Re: 526 Post Road/Arundel Lane –Drainage Review Memo – Tax Map 27, Lot 10

**Drainage Analysis/ Model Review/Plan Review**

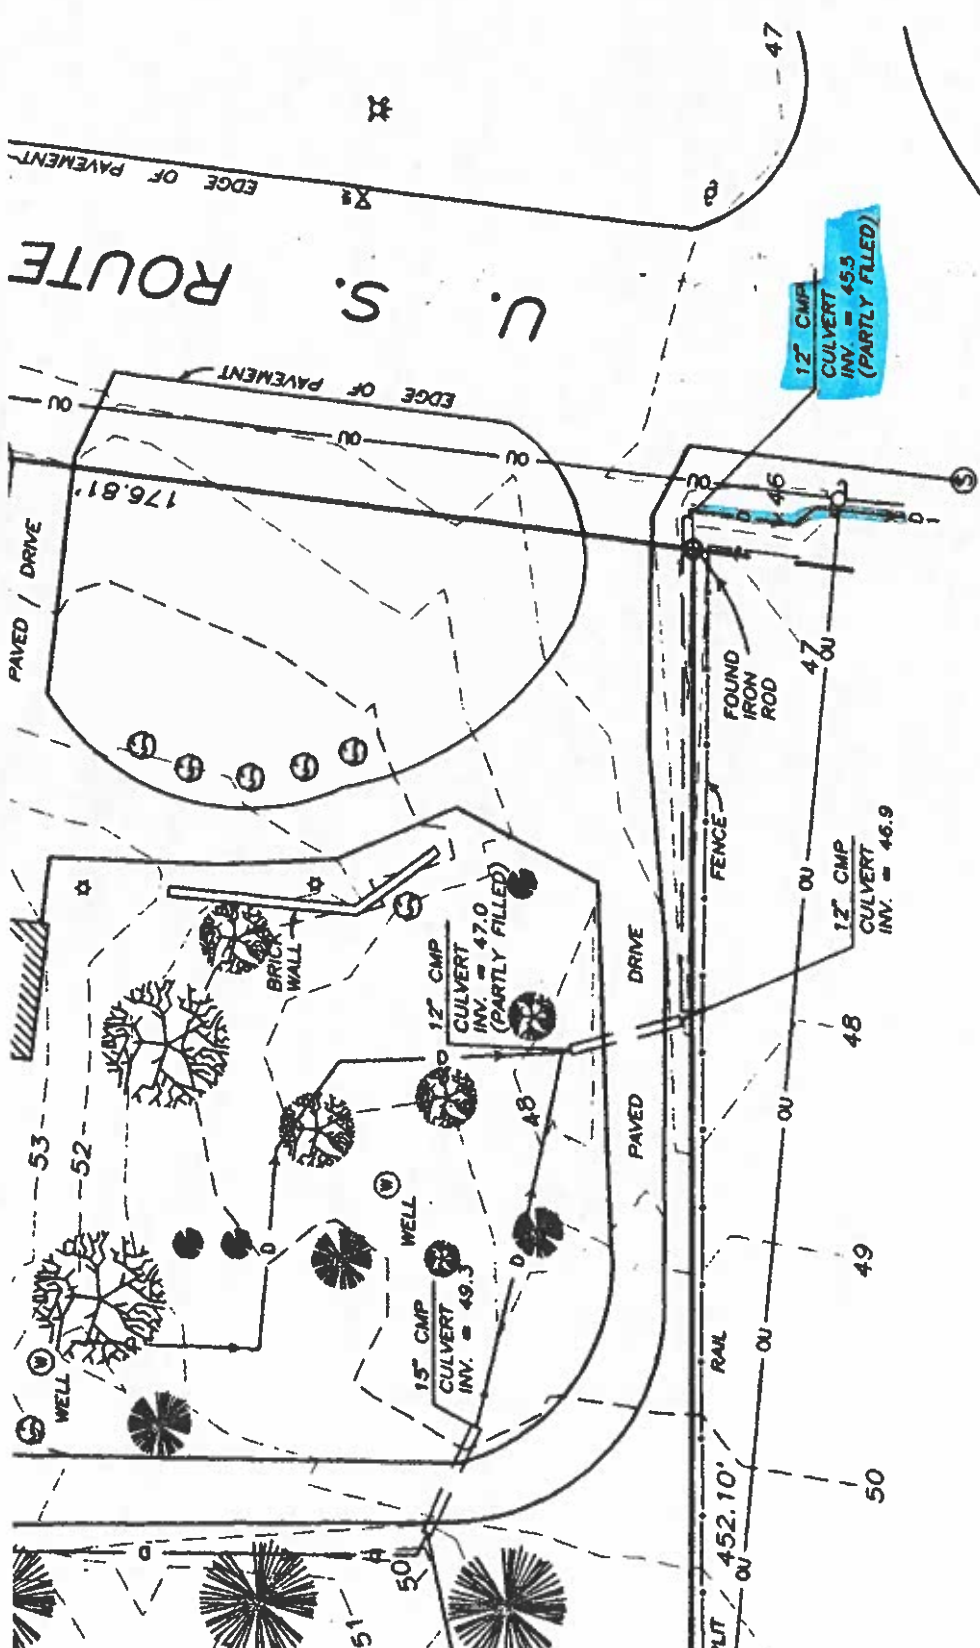
- o Existing drainage structure and elevation at Route 1 needs to be verified. See attached plans with varying information.

12' CMP CULVERT INV. = 45.5 (PARTLY FILLED)

12' CMP CULVERT INV. = 47.0 (PARTLY FILLED)

15' CMP CULVERT INV. = 49.3

12' CMP CULVERT INV. = 46.9

12' CMP CULVERT INV. = 45.5 (PARTLY FILLED)
